PROPOSED HARTLEY ROAD ELECTRICAL SUBSTATION

Hartley Road and Cheechunk Road
Goshen, New York

FINAL ENVIRONMENTAL IMPACT STATEMENT

SITE VICINITY MAP

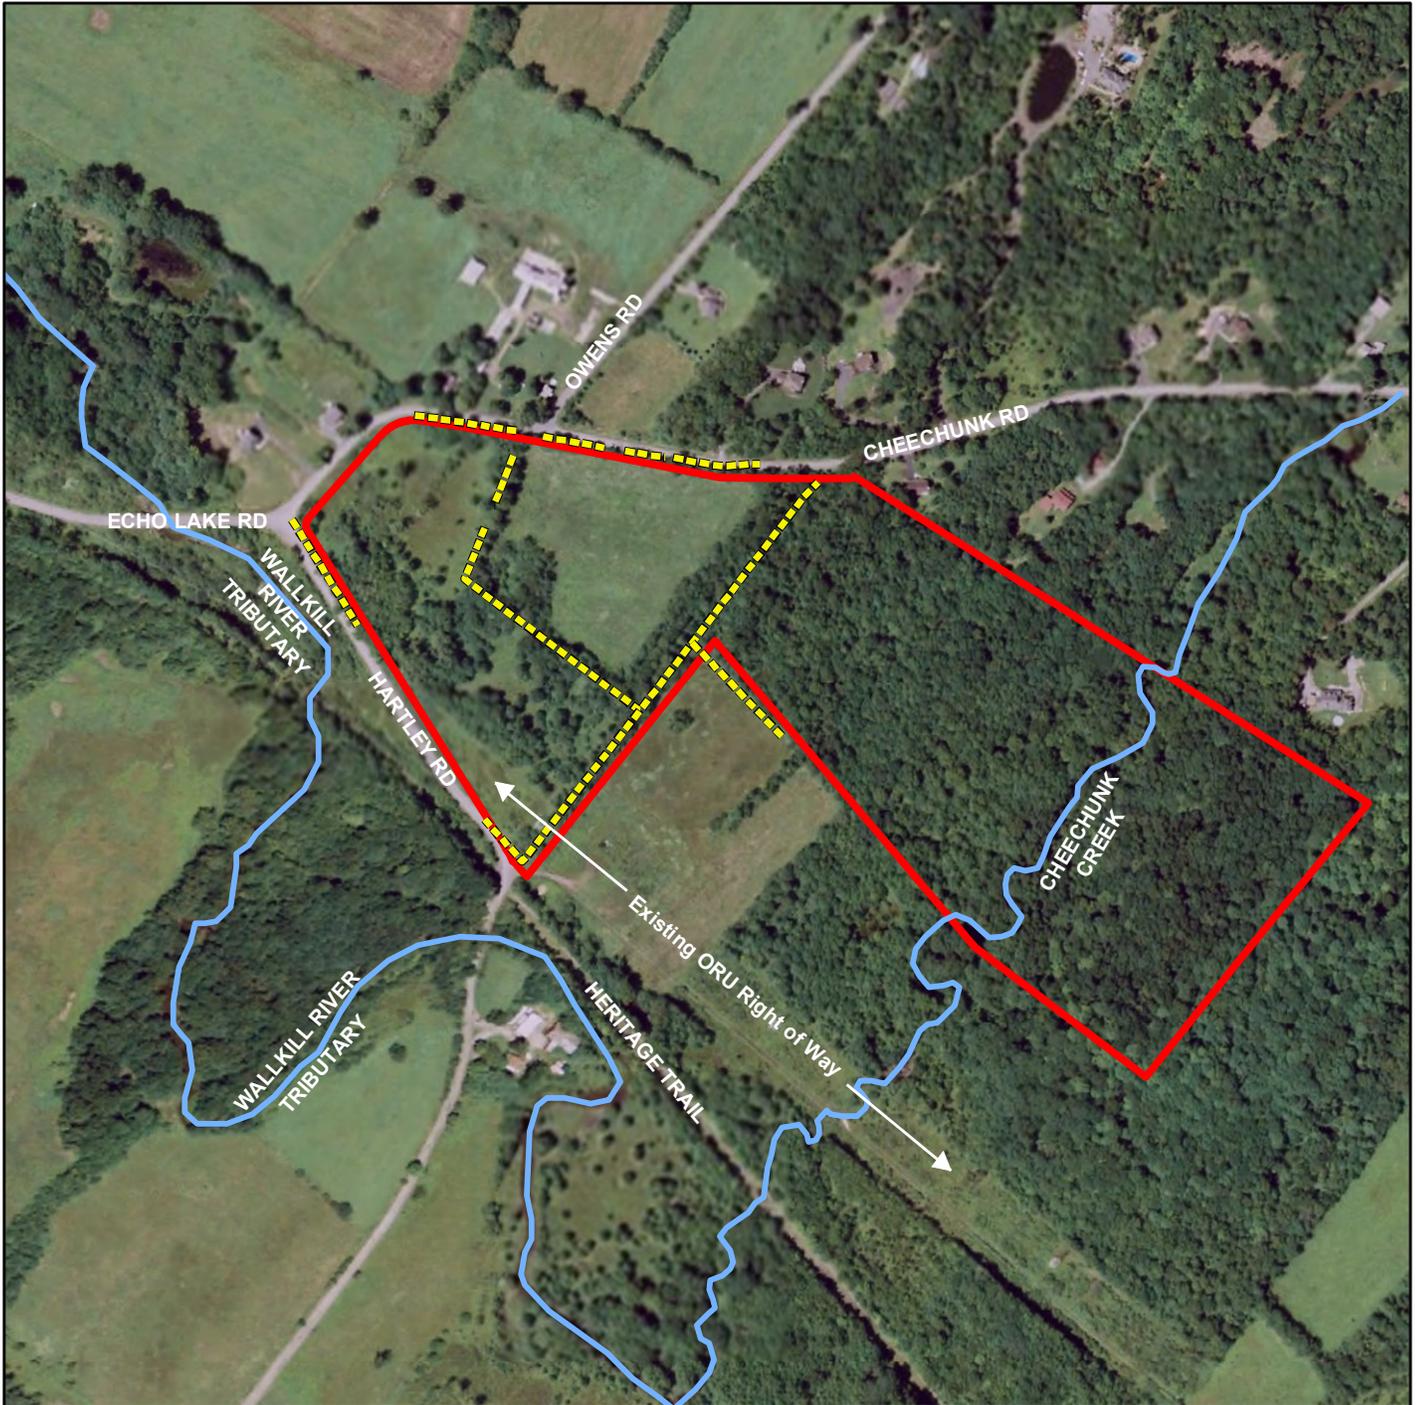
Public Comment 9: FEIS should indicate Cheechunk Road was formerly known as Strey Road and Owens Road was formerly known as Ingersol Road, as identified on the USGS Topographic Map used in Figure 1. (Riddick, 1/13/2012).

FIGURE
5

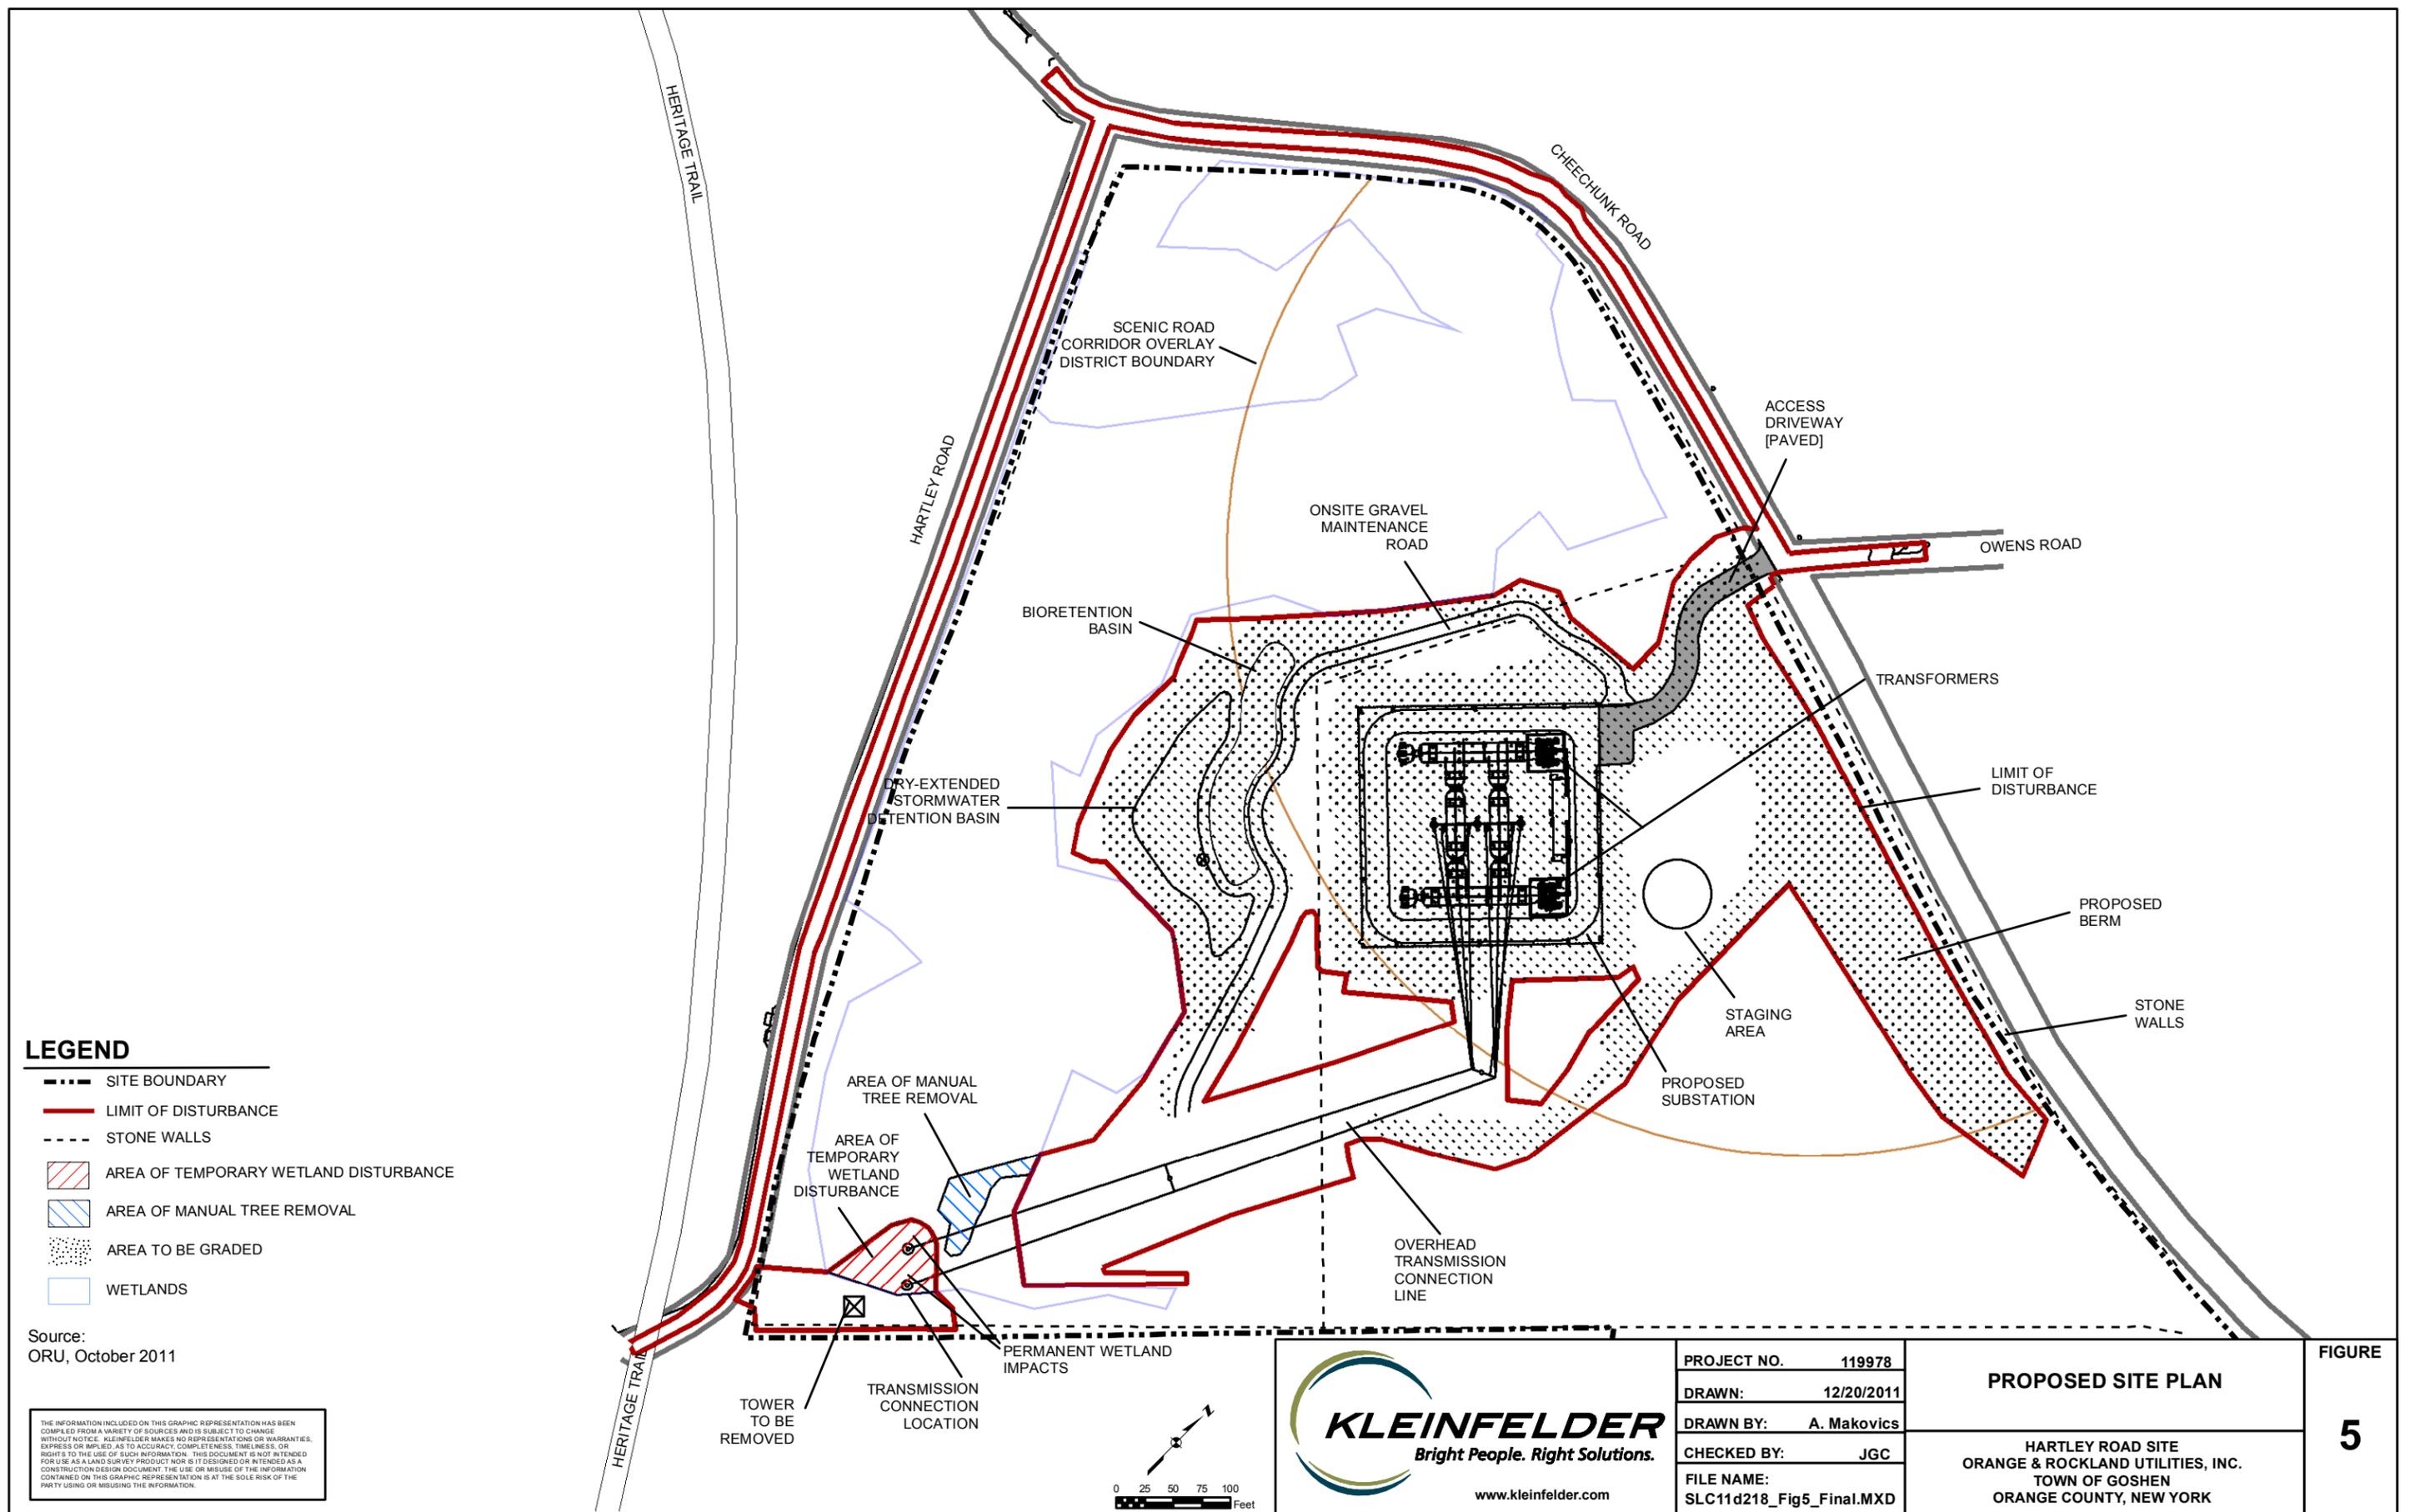
Public Comment 35: Figure 5 indicates a 4'-6' berm will be constructed to the east of the proposed entrance; however, a berm should also be constructed west of the entrance as well. This will minimize visual impacts in this part of the scenic corridor. Both berms should not be designed as mounds of linear dirt, but rather integrated into the landscape organically, as if there naturally. The east berm has ample land where a berm can meander between the road and substation, (Orange County Department of Planning, 2/6/2012).

CAD FILE: L:\2011\Projects\119978\ LAYOUT: FIG 6

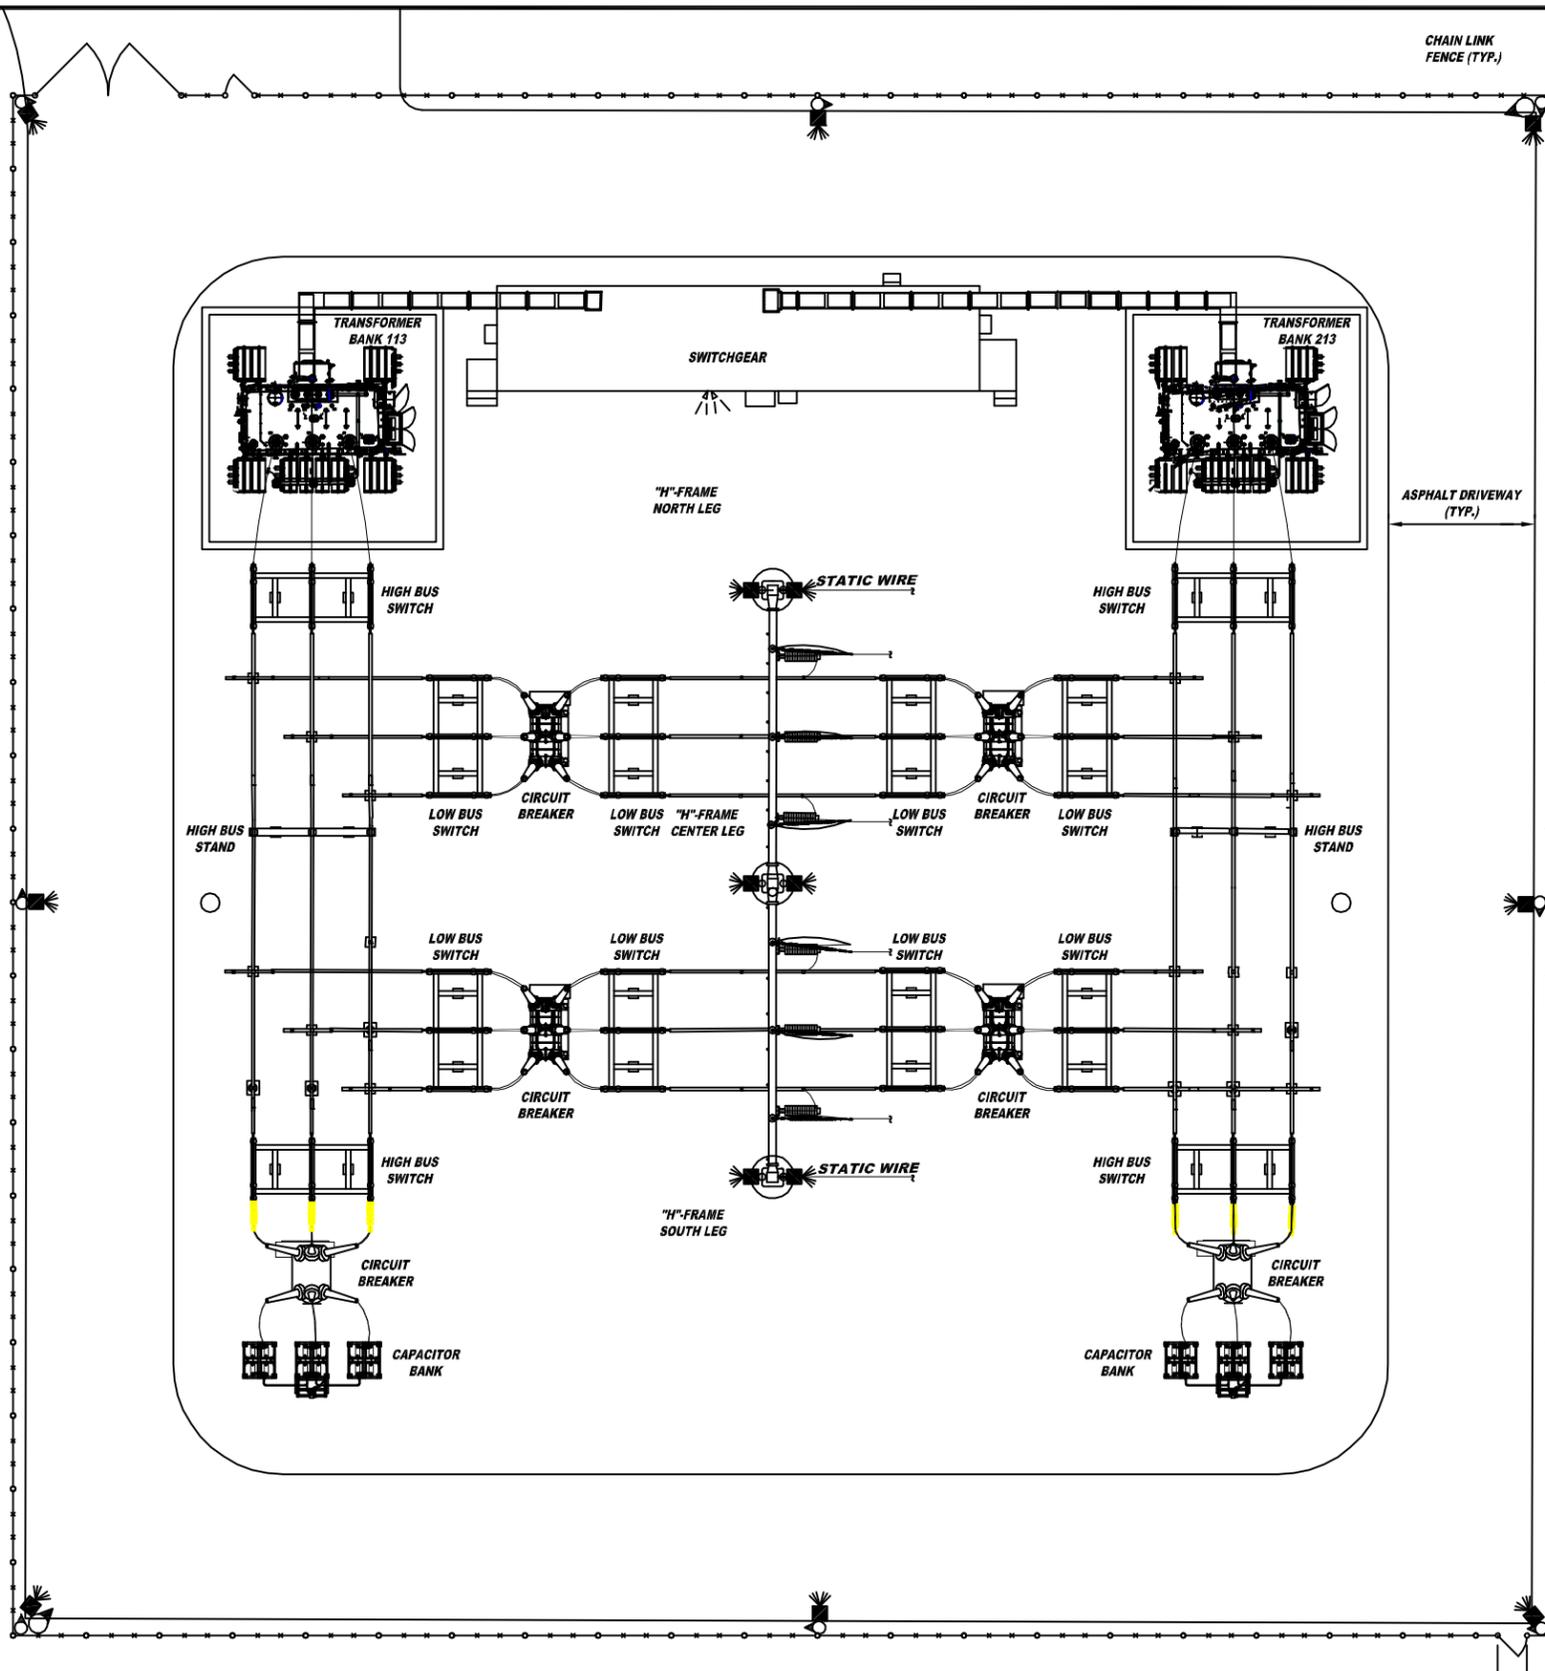
Public Comment 11: –*DEIS indicates cameras will be installed around the fence for security. Figure 6 indicates infrared (IR) illuminator. FEIS should confirm the security cameras with the IR illuminators eliminate the need to routinely activate the site lighting during camera use. (Riddick, 1/13/2012).*

Public Comment 31: DEIS indicates 14 total lights; FEIS should revise count to 15 lights to include the wall mounted fixture above the switchgear as shown in Figures 6 & 14. (Riddick, 1/13/2012).

Response: *As shown in Figure 6 the security cameras installed around the fence perimeter will be equipped with infrared (IR) illuminators. This will eliminate the need to activate the Site lighting when the cameras are in use. The text has been revised to reflect this information.*

PROJECT NO. 126473	DISTRIBUTION IMPROVEMENTS PLAN	FIGURE 7
	DRAWN: 01 May 2012		
	DRAWN BY: AM	HARTLEY ROAD SITE ORANGE & ROCKLAND UTILITIES, INC. TOWN OF GOSHEN ORANGE COUNTY, NEW YORK	
	CHECKED BY: JGC		
FILE NAME: Figure35A.MXD

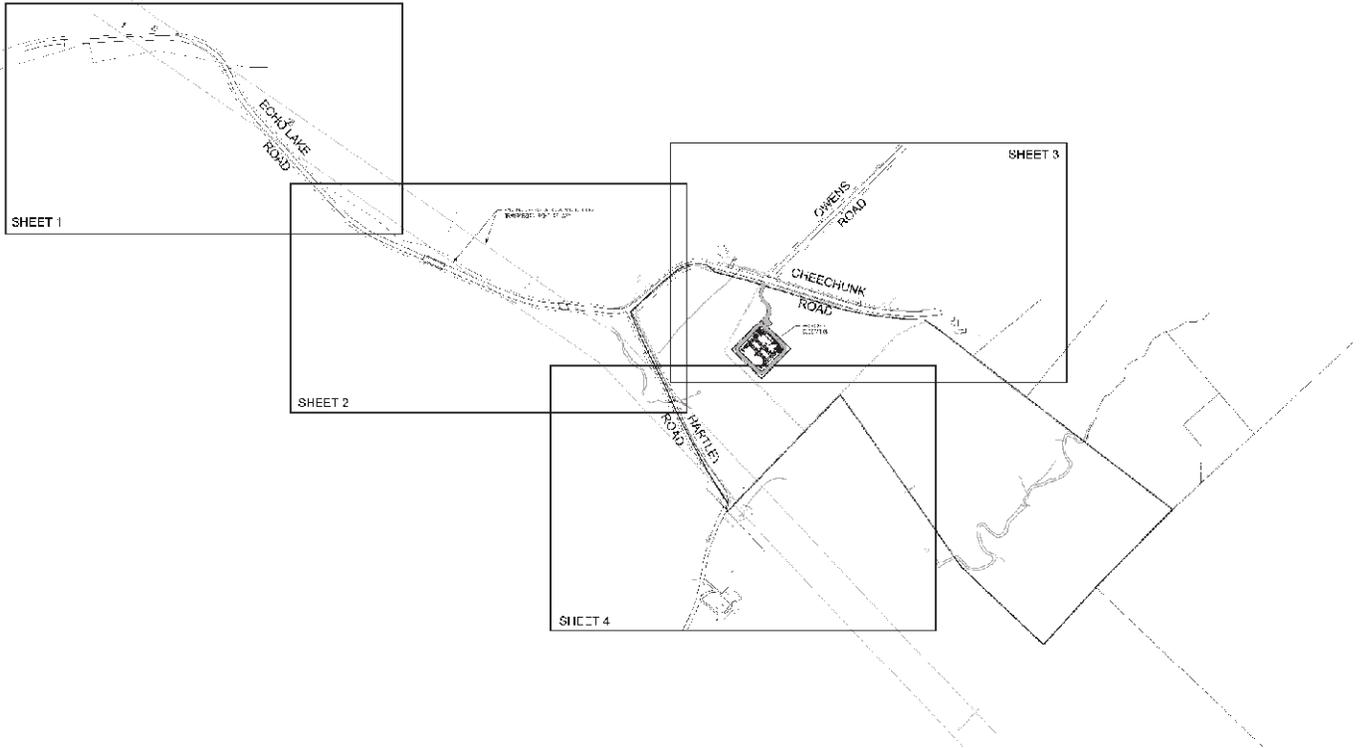
***Public Comment 1:** DEIS discusses generally electrical distribution system improvements along Cheechunk, Owens, Echo Lake and Hartley Roads within the Town's right-of-way. Figure 5 shows underground electrical work along Echo Lake Road only. FEIS should clarify the description with figures for each road as well as plans showing limits and type of work (underground, overhead, structures) within Town's right-of-way.(Riddick, 1/13/2012).*

Response: Figure 7 has been revised to show a key map of a plan set entitled “Underground/Overhead Distribution Improvements”. This plan set (Appendix B1) has been created in order to enlarge the scale and show the proposed electrical work along Echo Lake (Sheets 1 & 2), Cheechunk (Sheets 2 & 3), Owens (Sheet 3) and Hartley Roads (Sheets 2 & 3). All underground improvements will be coordinated with the Town Highway Superintendent and be conducted in accordance with trench restoration details for road pavement or road shoulder (Appendix C3).
